# FRONT SUSPENSION

## DESCRIPTION

SA084-01

R02922

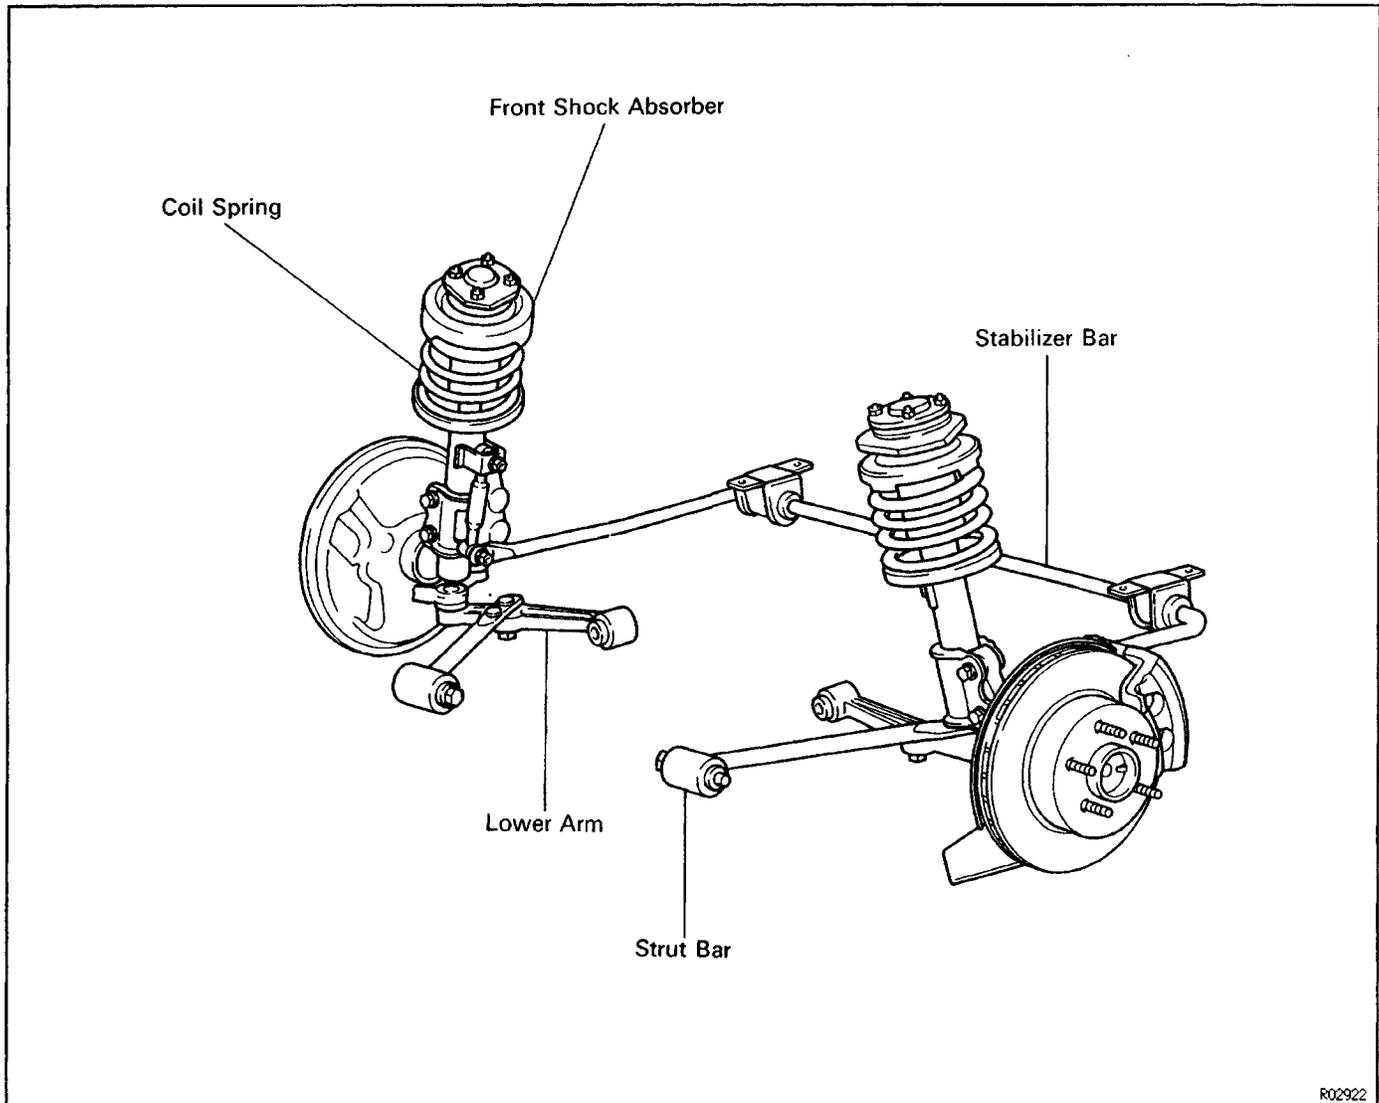
The front suspension of the new model use MacPherson struts as in the previous model.

The strut bar changed the cushion type into the bushing type.

The basic construction and operation remain the same, but the suspension geometry and the bushings have been modified to improve stability and riding comfort.
